**RE: December 1, 2021 Meeting  
64 Vaughan Mall Restoration  
Portsmouth, NH 03801**

Attention: Historic District Commission  
RE: 64 Vaughan Mall (LU-20-214)

The applicant for the Restoration of 64 Vaughan Mall wishes to review the following discussion points at the December 1, 2021 Public Hearing in regards to the stipulations and open items for the project.

A1.1

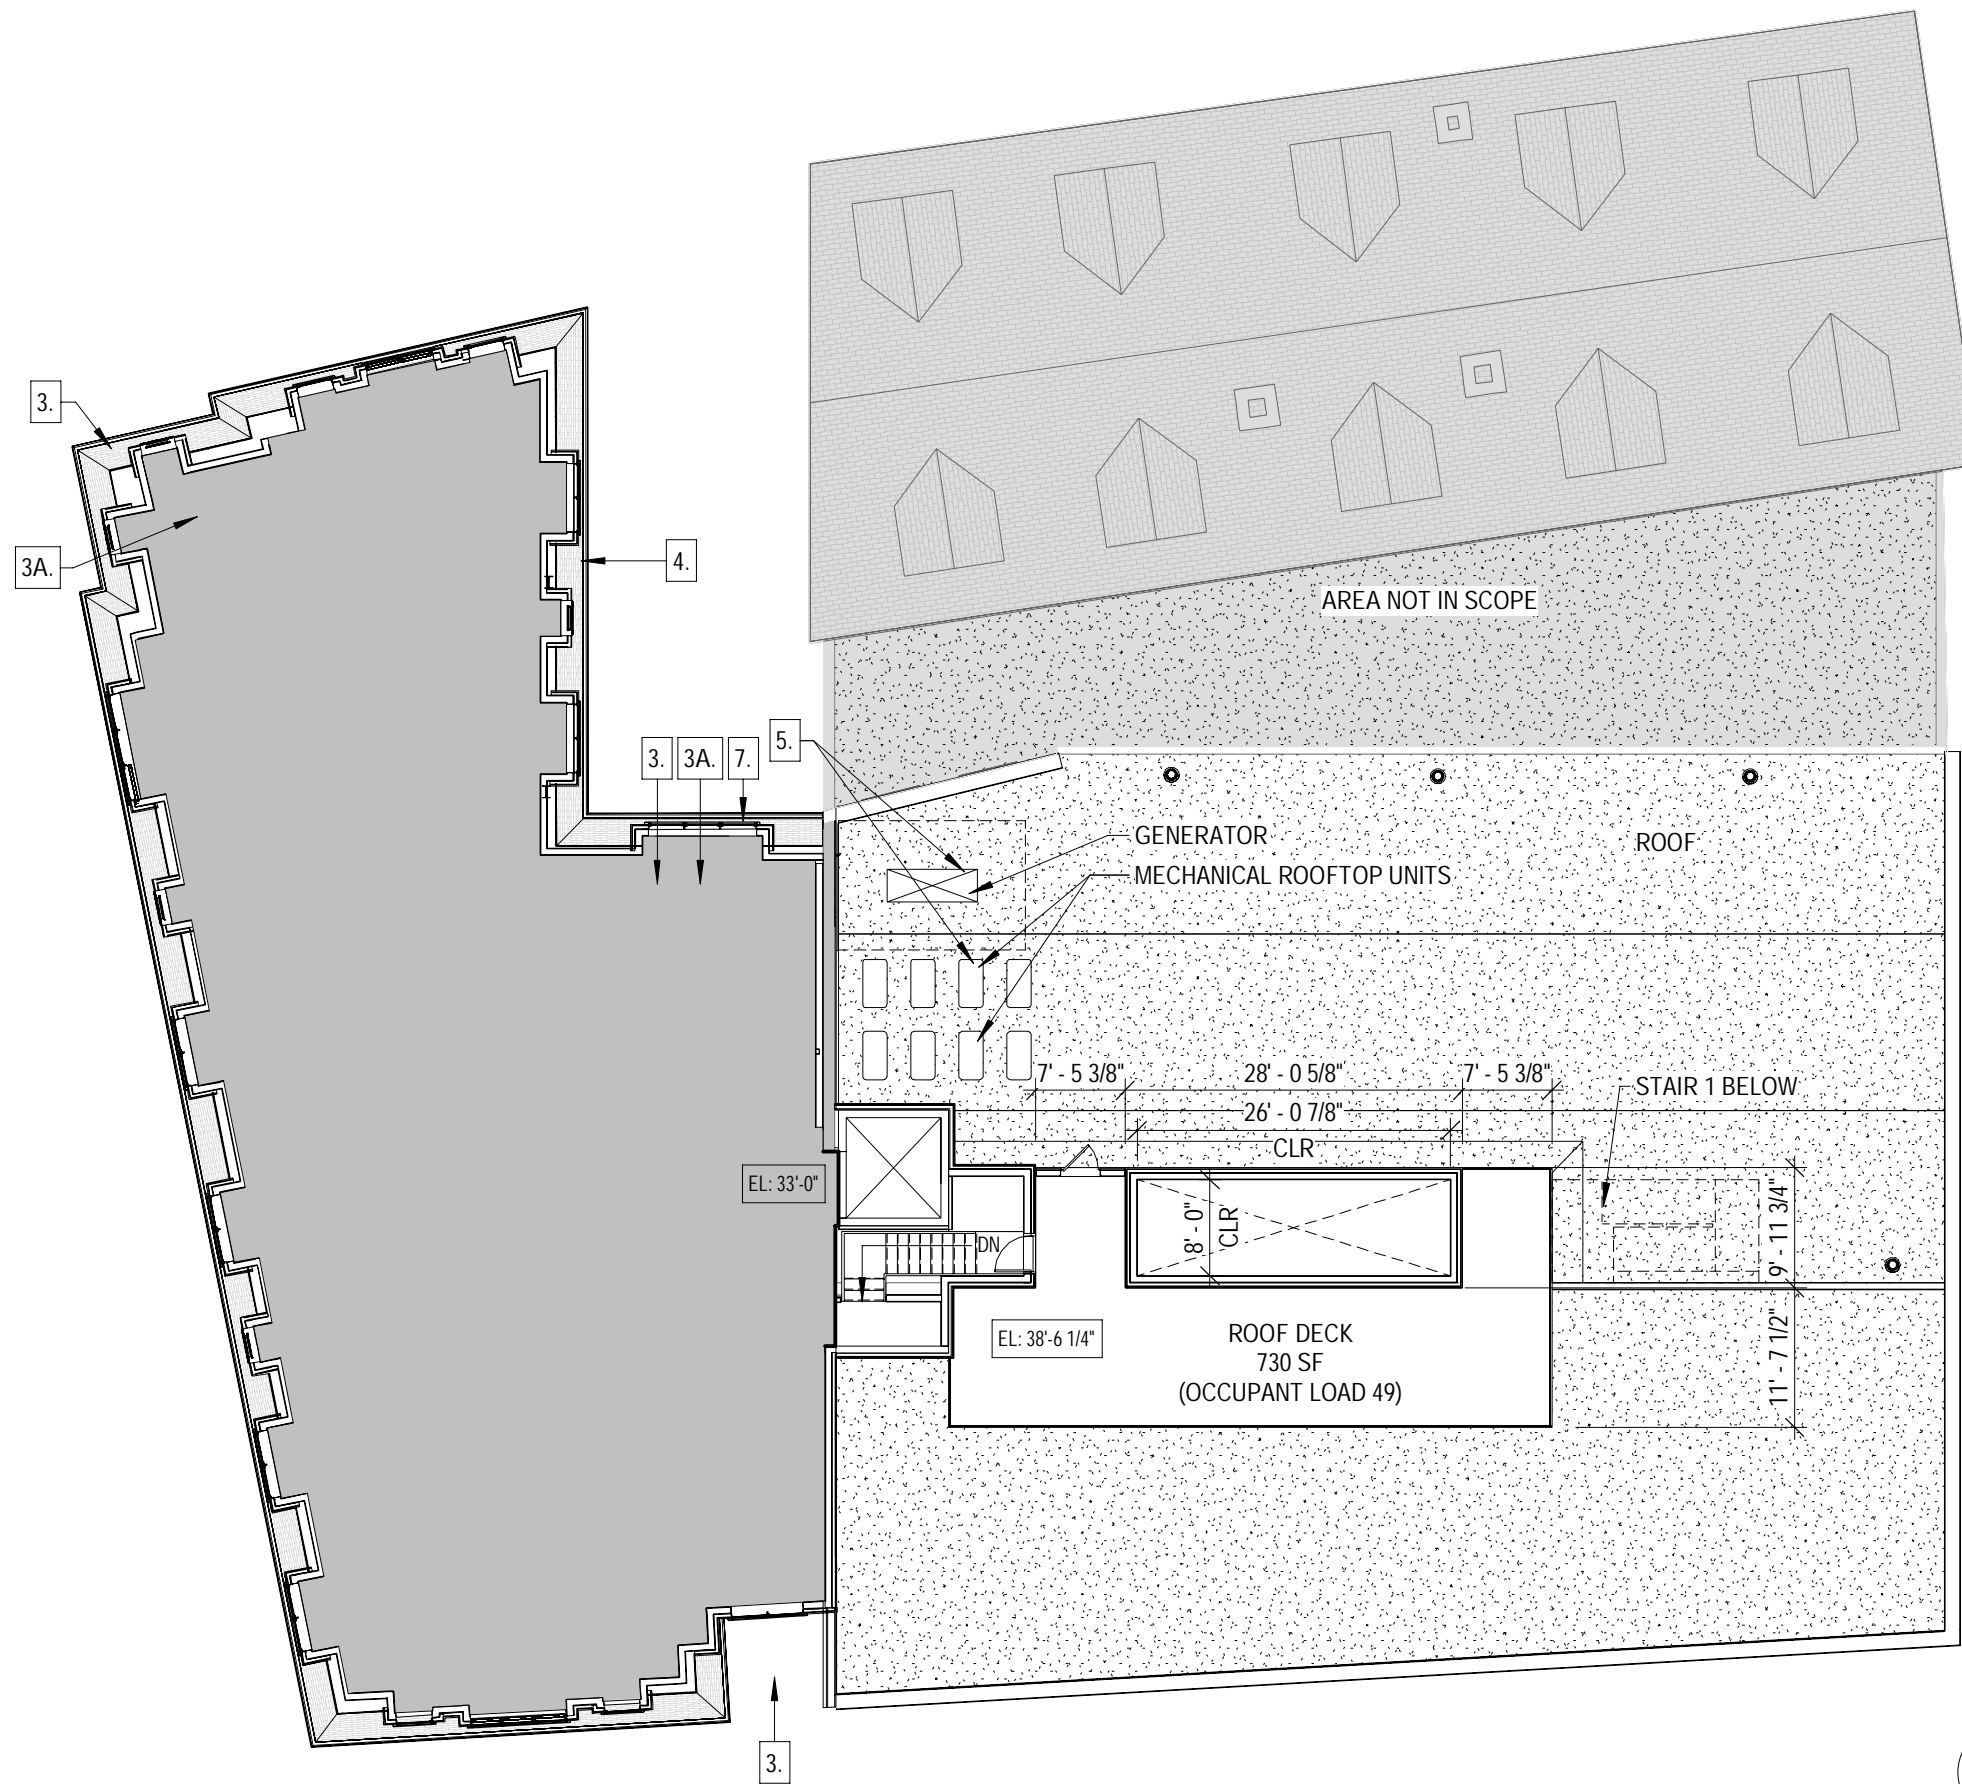
| HDC REVISION KEY NOTES |  |
|------------------------|--|
| 1.                     | HANOVER STREET ENTRY AND RAMP REMOVED. REPLACED 5 METAL PANELS WITH 4 STOREFRONT WINDOW SYSTEMS. |
| 2.                     | REVISED LAYOUT OF STOREFRONT AT VAUGHAN MALL ENTRANCE.   |
| 3.                     | REMOVED EXTERIOR DECKS.  |
| 3A.                    | INFILL OF DECK WITH INTERIOR FLOOR   |
| 4.                     | MOVED EXTERIOR WALLS TO ALIGN WITH FIRST FLOOR EXTERIOR BELOW.                                   |

**A1.4** **FOURTH FLOOR PLAN**  
**64 Vaughan Mall**  
 11/19/2021  
 SCALE: As indicated

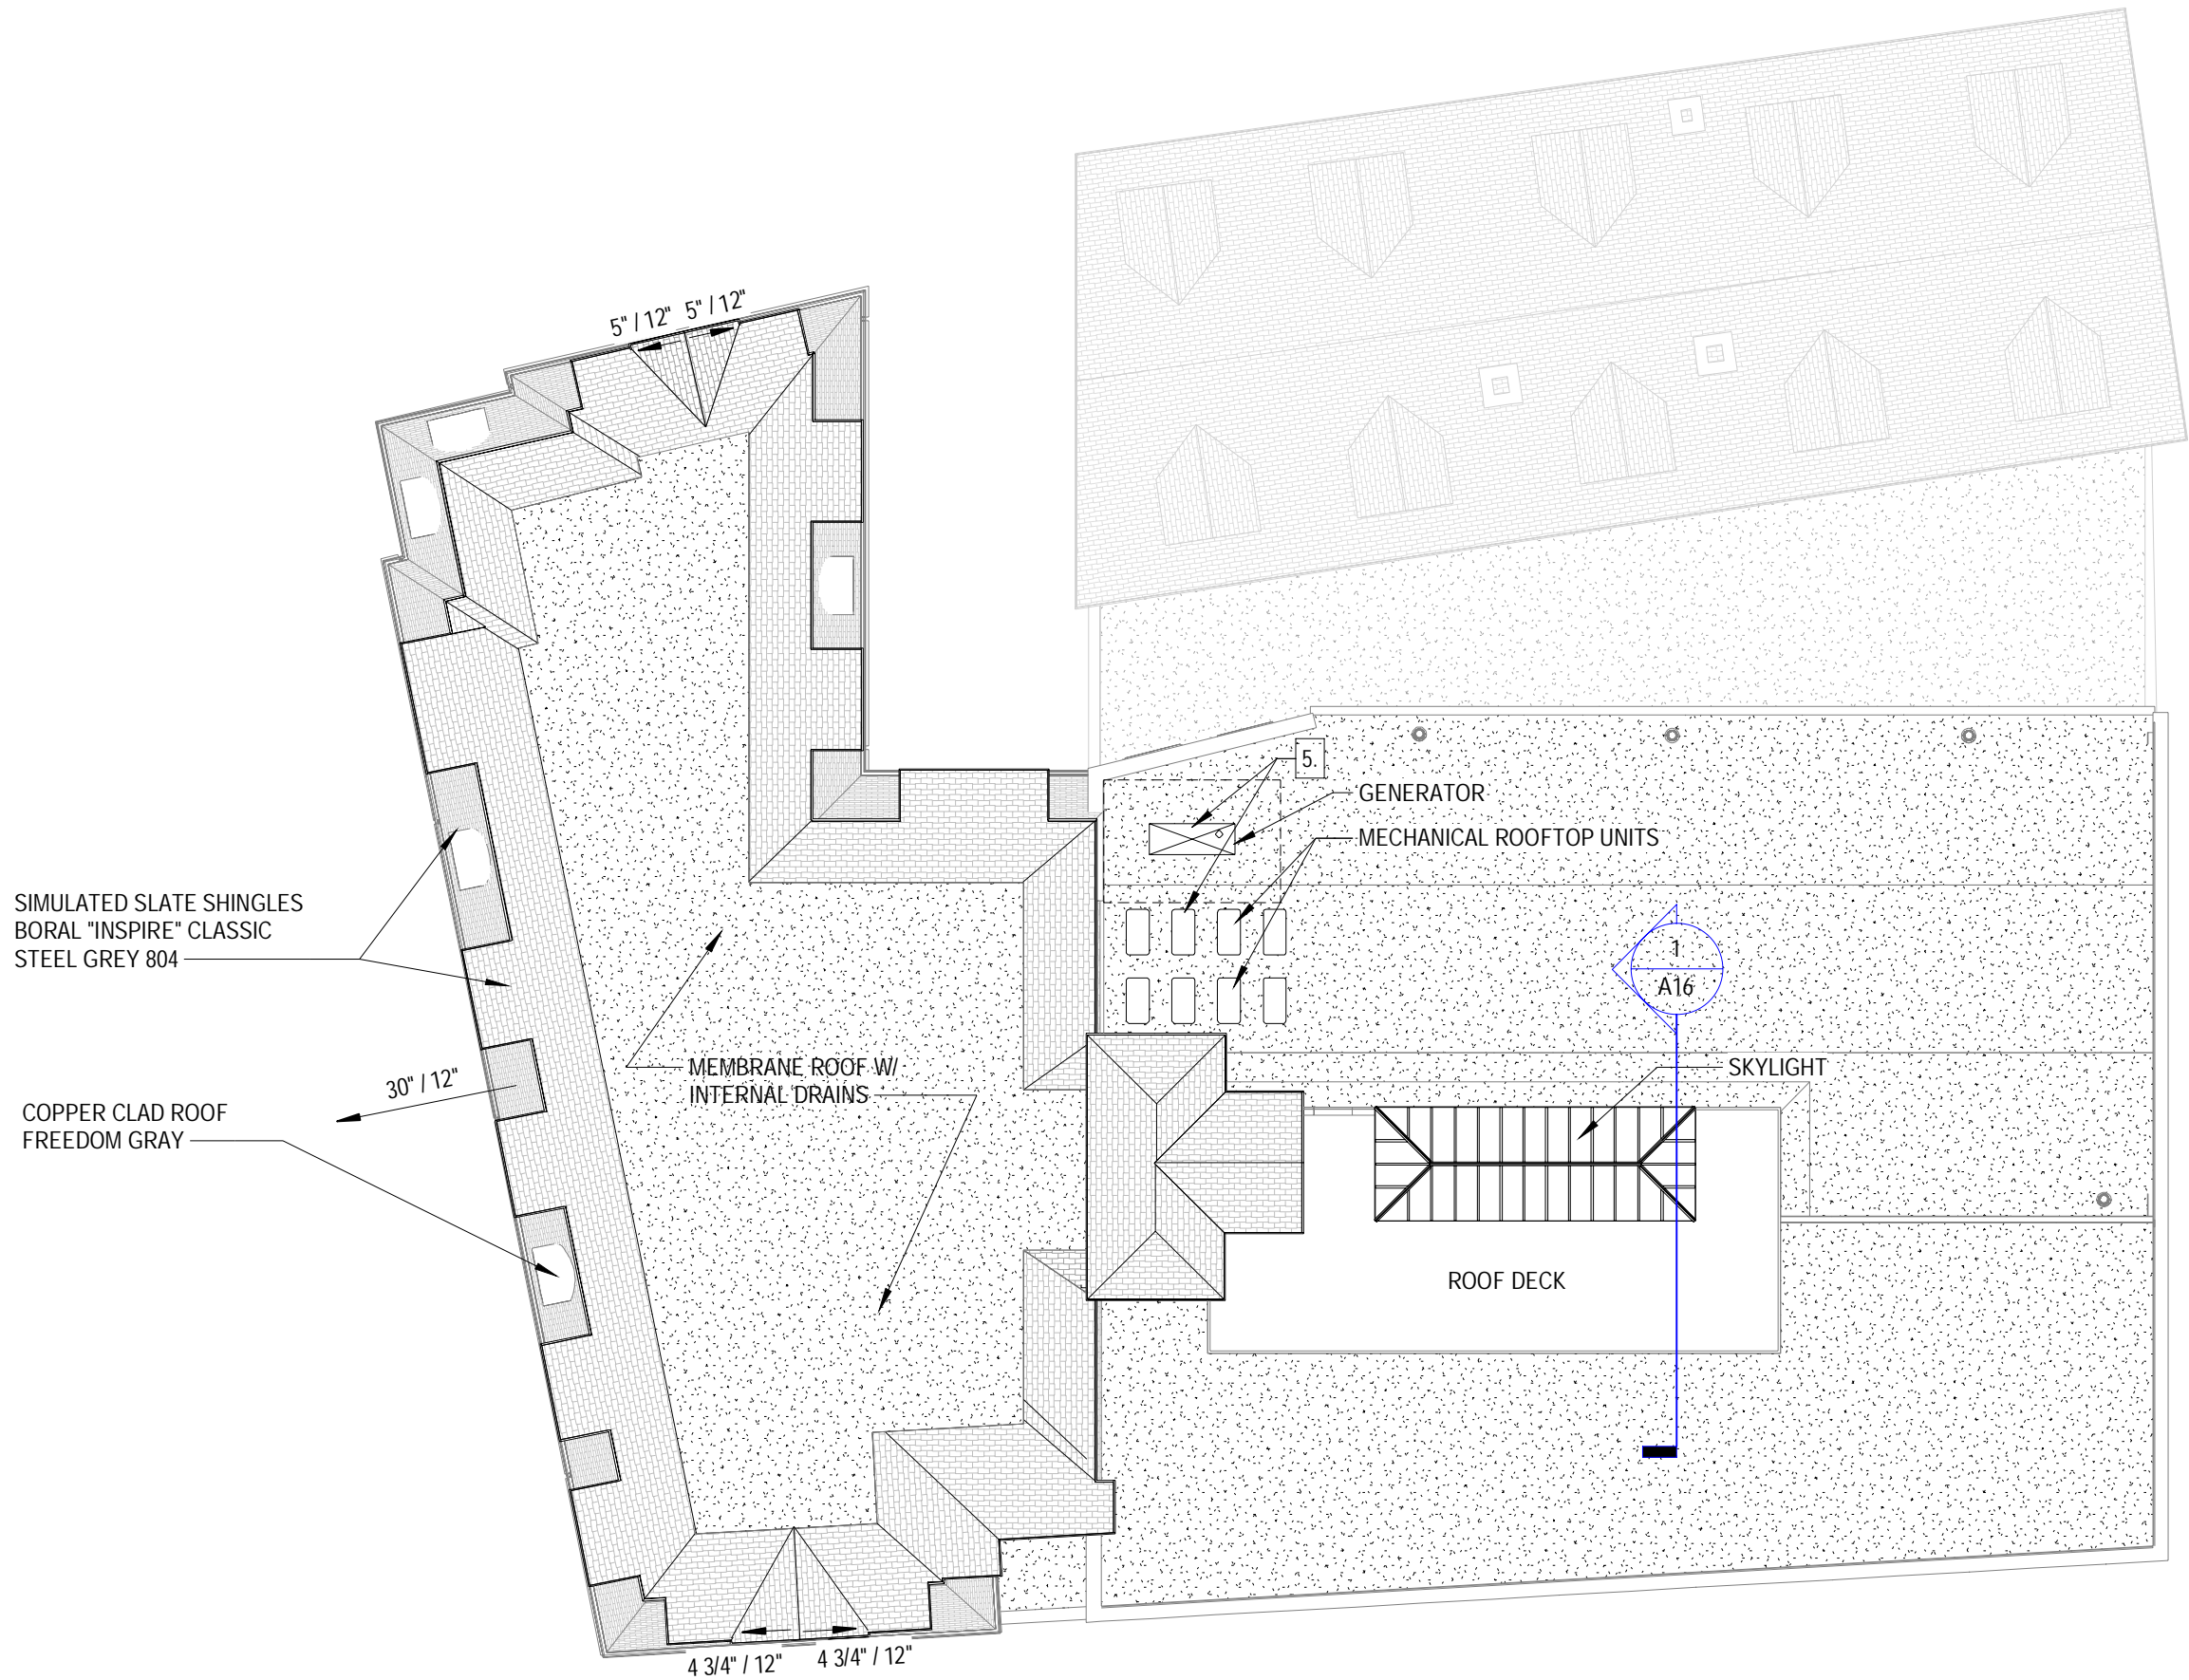
| HDC REVISION KEY NOTES |  |
|------------------------|--|
| 1.                     | HANOVER STREET ENTRY AND RAMP REMOVED. REPLACED 5 METAL PANELS WITH 4 STOREFRONT WINDOW SYSTEMS. |
| 2.                     | REVISED LAYOUT OF STOREFRONT AT VAUGHAN MALL ENTRANCE.   |
| 3.                     | REMOVED EXTERIOR DECKS.  |
| 3A.                    | INFILL OF DECK WITH INTERIOR FLOOR   |
| 4.                     | MOVED EXTERIOR WALLS TO ALIGN WITH FIRST FLOOR EXTERIOR BELOW.                                   |

ROOF PLAN

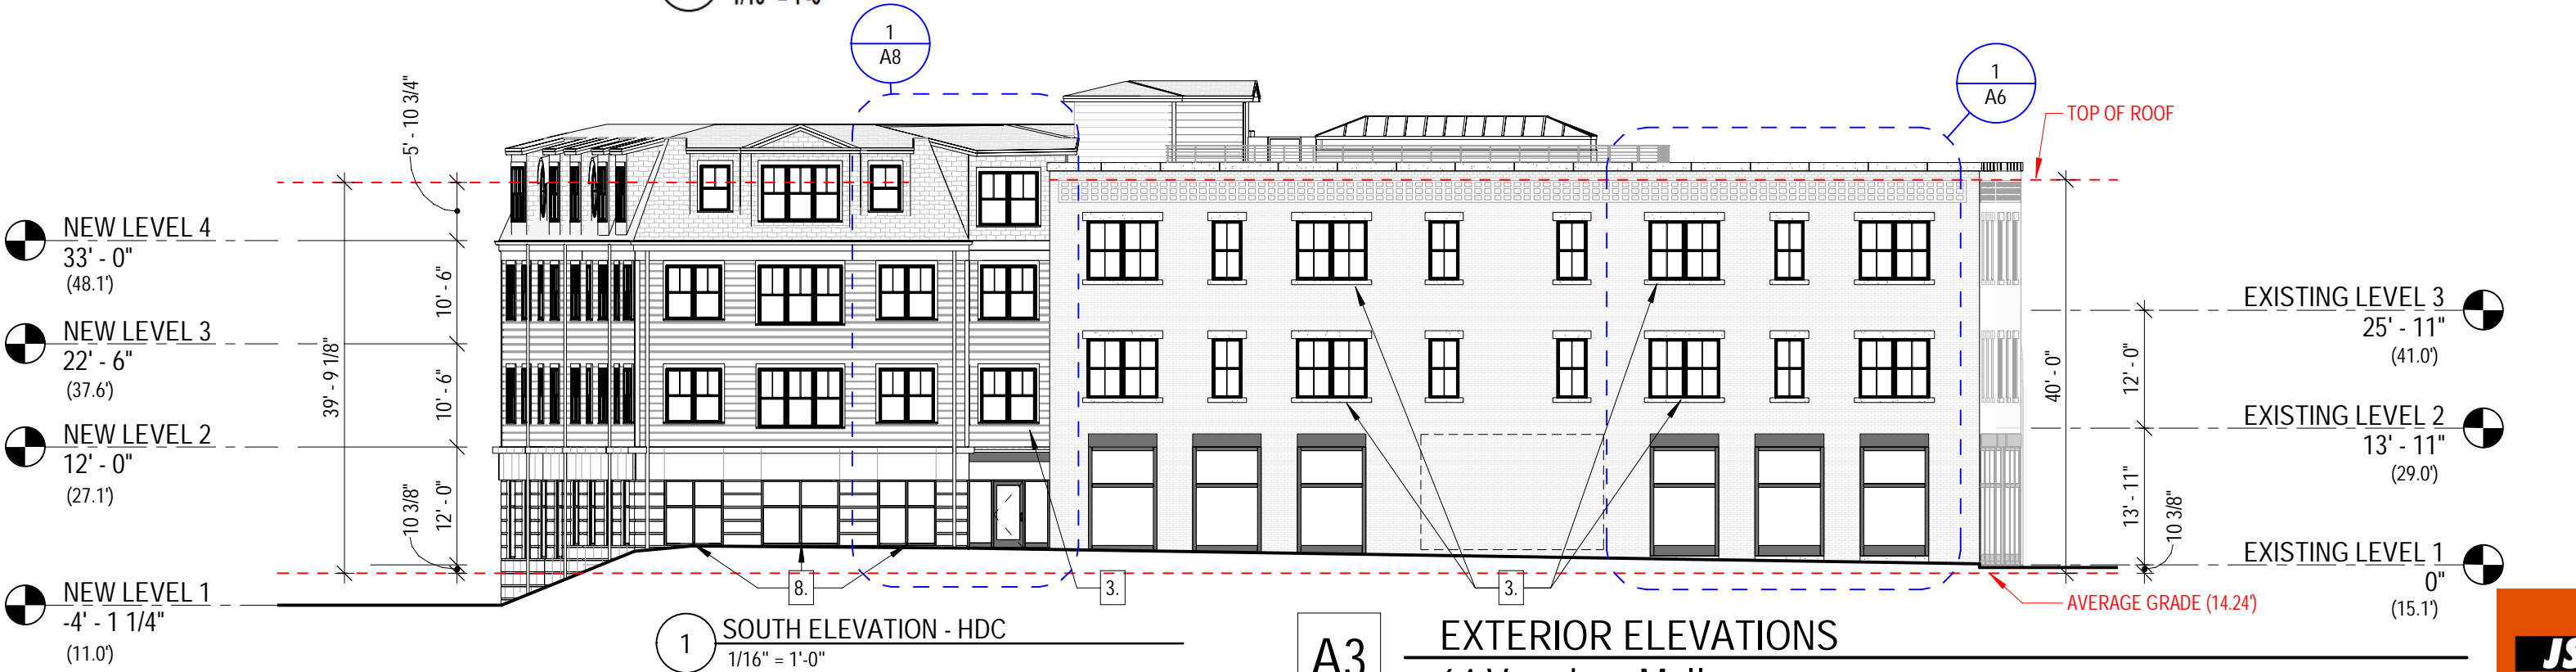
- HDC REVISION KEY NOTES**
- 1. HANOVER STREET ENTRY AND RAMP REMOVED. REPLACED 5 METAL PANELS WITH 4 STOREFRONT WINDOW SYSTEMS.
  - 2. REVISED LAYOUT OF STOREFRONT AT VAUGHAN MALL ENTRANCE.
  - 3. REMOVED EXTERIOR DECKS.
  - 3A. INFILL OF DECK WITH INTERIOR FLOOR.
  - 4. MOVED EXTERIOR WALLS TO ALIGN WITH FIRST FLOOR EXTERIOR BELOW.
  - 5. RELOCATED MECHANICAL ROOF UNITS.
  - 6. CENTERED WINDOWS.
  - 7. RESIZED WINDOWS AND CENTERED WINDOWS.
  - 8. ADDED HORIZONTAL MULLIONS TO STOREFRONTS.
